Number: TSB-FC-2015-041 SW8000/SC8000
LP Vaporizer Recall

Date: September 29th, 2015

Engine Propane (LP) Vaporizer

FIELD CORRECTIVE ACTIONS: (All machines built prior to Serial Number 1000059228)

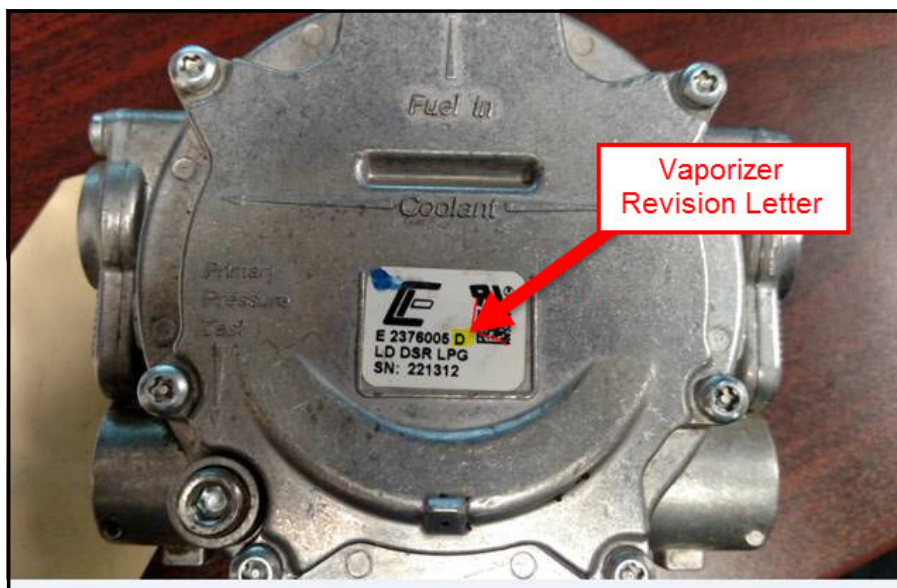
LP Vaporizers with REV A, B, C & D have an over pressurization routing path that is external. If the diaphragm material has degraded or ripped, most often due to lower quality fuel, the fuel system becomes over pressurized. The LP lock-off shuts off the fuel supply due to over pressurization. The small amount of fuel trapped inside the Vaporizer is then exhausted out the vent hole.

If the Propane Vaporizer is Revision A, B, C, or D, then it should be replaced with a new one. Replace the old Vaporizer with the new one and submit a completed warranty claims for reimbursement for the Vaporizer and for labor and travel.

All engines now built using LP Vaporizer REV E or later. These Vaporizers are built with a more robust diaphragm material and the over pressurization routing has changed so that it now vents internally.

56107646 VAPORIZER - to prevent potential weeping of LP
